Comfit Composite Knit LTD (Unit 2)

Amtola, Kathgora Bazar, Ashulia, Savar, Dhaka
(+23.907331N, 90.288456E)
29th March 2014

Executive Summary (Continued)

Building Observations

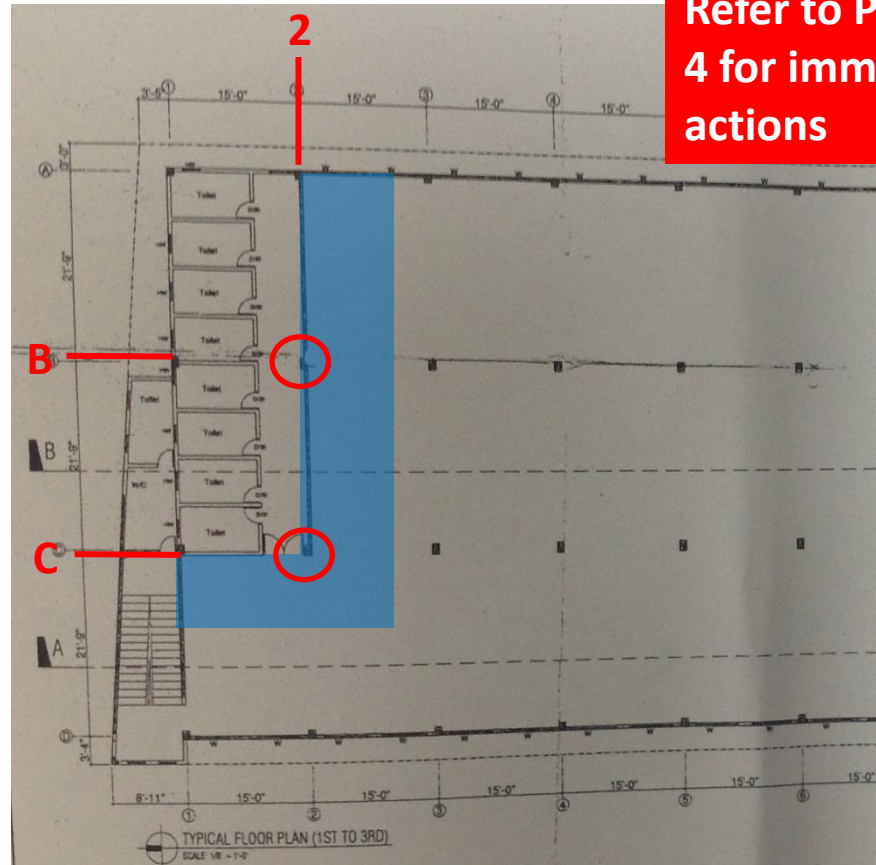
Columns appear to be stressed in excess of normal design limits

Due to the heavy floor construction in the toilet areas at 1st to 3rd Floors, outline calculations indicate that the columns on Gridline 2 are highly stressed to levels that require immediate review

Refer to Pages 3 and 4 for immediate actions

Typical column layout

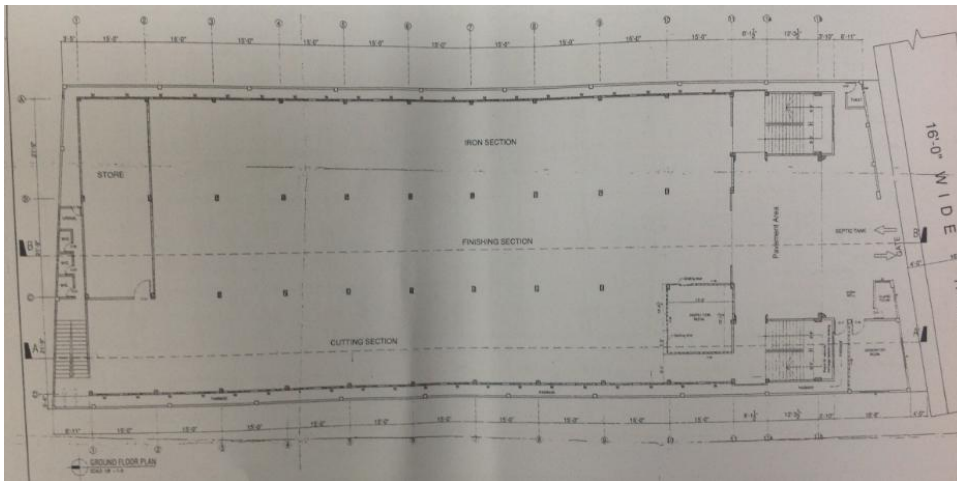
Area highlighted to be vacated and Specific design check to be carried out on columns at ground floor level which support heavy toilet floor construction

Outline calculations indicate that column sizes appear to be smaller than required by code for the applied dead and live load, assuming typical concrete strength

Building Engineer to perform detailed calculations and concrete tests to prove column size and (if required) :

- Reduce loads further by preparation of allowable floor loading plans
- Carry out strengthening works

Stairwell cantilever beam

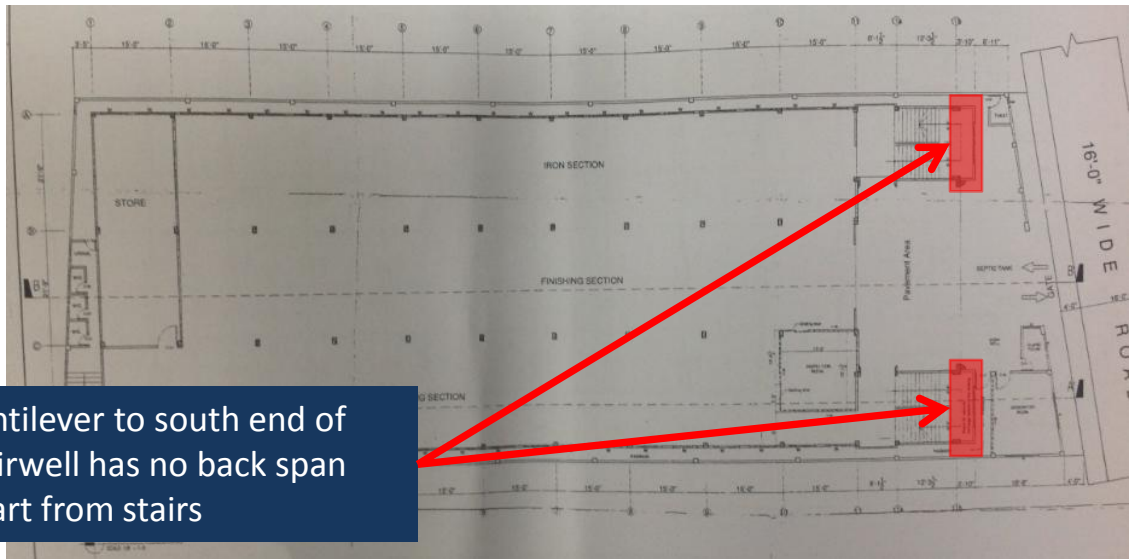
Adequacy of stairwell cantilevers

Cantilever to south end of stairwell has no back span apart from stairs

Engineer to verify as-built arrangement of stairwells, including cantilever beam, landing slab and supporting column adequacy.

Typical floor plan showing cantilevering half landings

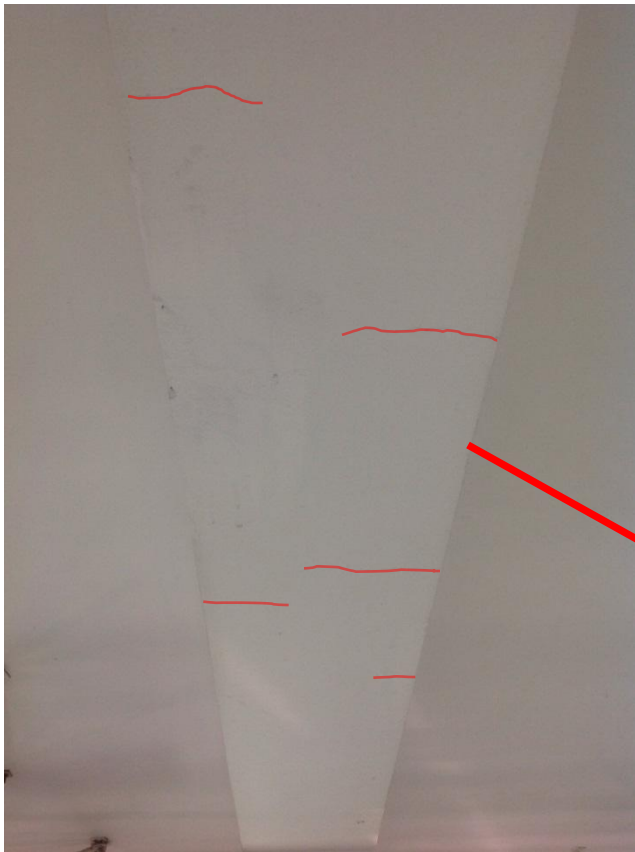
Cracking was noted in brickwork on exterior of stairwell

Cracking at soffit to beam supporting 2nd floor slab

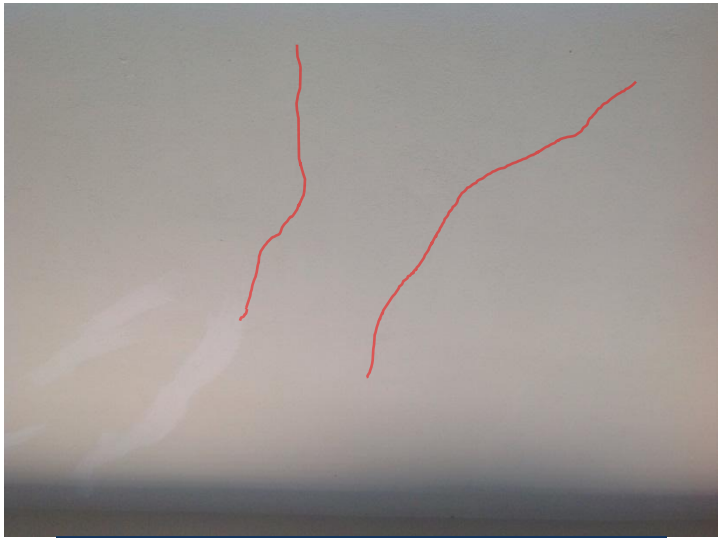
Hairline cracking to beams and soffits of slabs

Cracking at soffit to fourth floor slab

Typical plan showing crack locations on suspended slabs

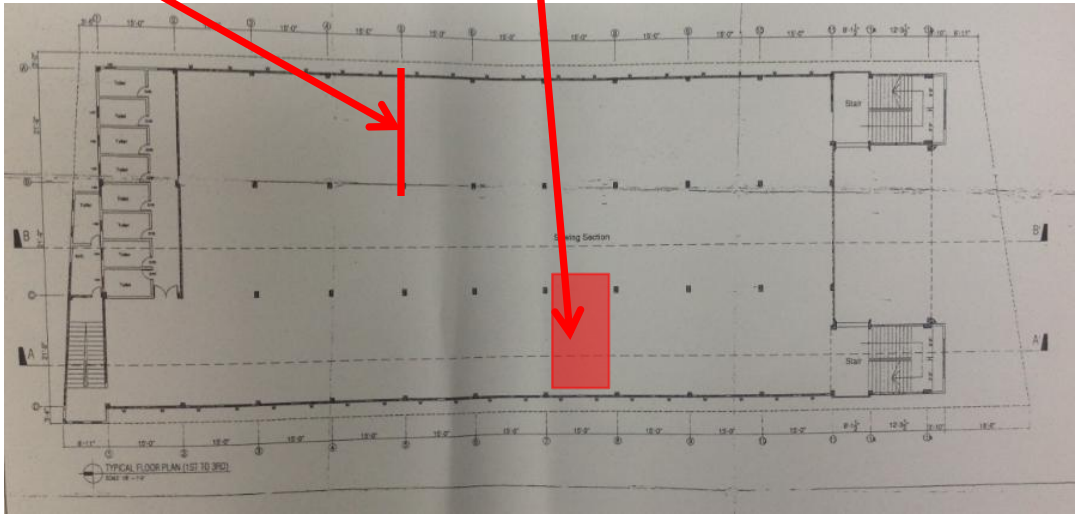
Cracking to concrete structure
